Interior - Driver's Seat Won't Move Forward/Backward

Classification:
EL02-023

Reference:
ITB00-067a

2000-2001 I30 AND 2002 I35; DRIVER'S SEAT WILL NOT MOVE FORWARD OR BACKWARD

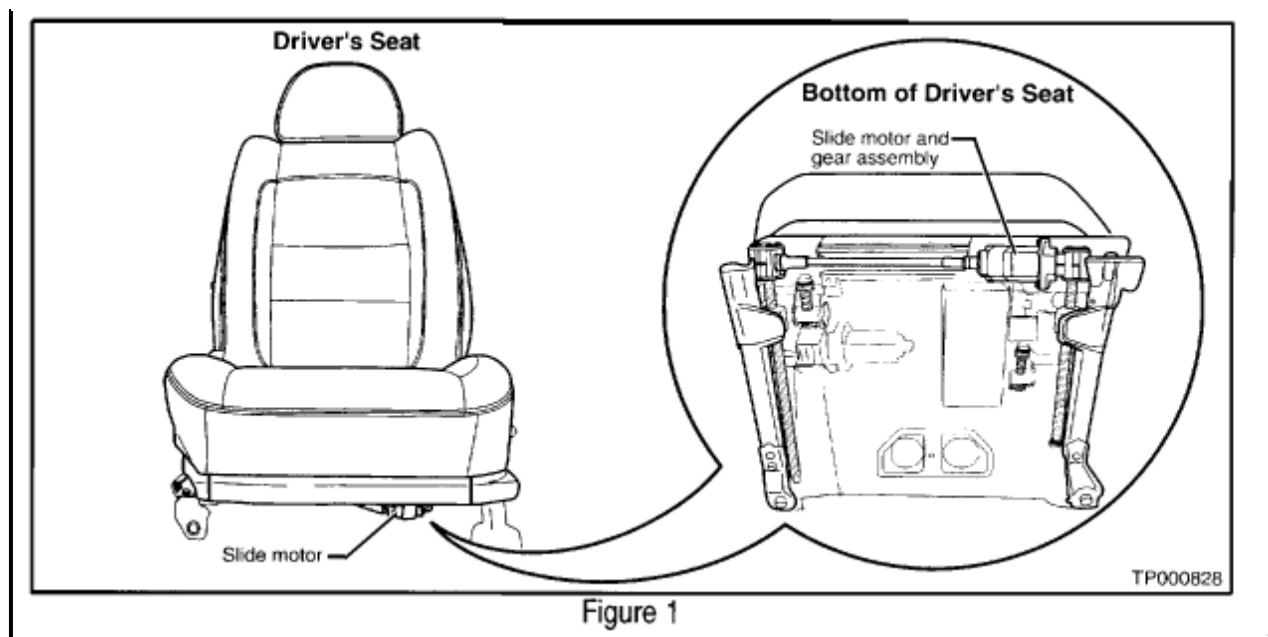
If the driver's seat in an applied vehicle will not move in the forward or backward direction, the seat slide motor and gear assembly may need replacement (see figure 1).

If this should occur, follow the Service Procedure in this bulletin to assist in diagnosing the incident and, if necessary, install the Seat Slide Motor kit (see the Parts Information section of this bulletin).
